## Reason for the Update

Compatibility issues with Firmware 3.2 and older hardware version CPU 2.XX.

- SD - Card with Firmware Version 3.3
- Update Instruction (this document)

Fig. 2: CPU firmware card and Simatic OP7 display

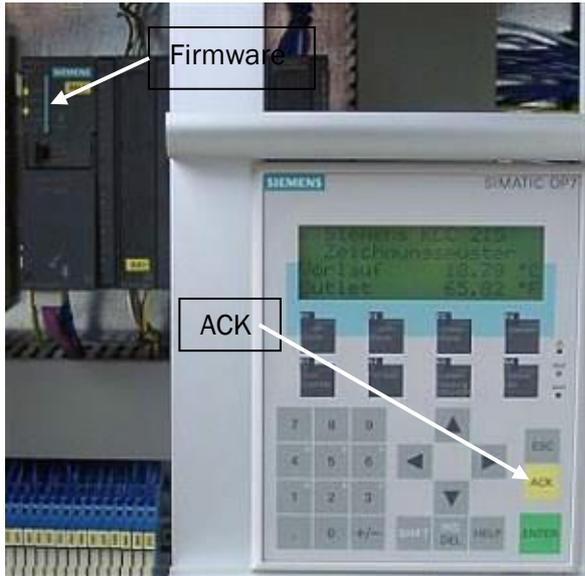
- Open the chiller door and identify the CPU board (Simatic S7-300), positioned left behind the Simatic operational panel OP7 (Fig. 2).
- Push down the release button below the CPU firmware card (Fig. 3) and remove the card.

- Insert the new firmware into the CPU board.
- Switch on the chiller via the large red main switch (door must be closed).
- Wait approx. 20 sec. and turn the chiller again OFF.
- Switch on the chiller again via the large red main switch (door must be closed).
- Check the Simatic operational panel OP7 (Fig. 2) for any error messages. In case of an error message, press the black reset button below the large red main switch and press
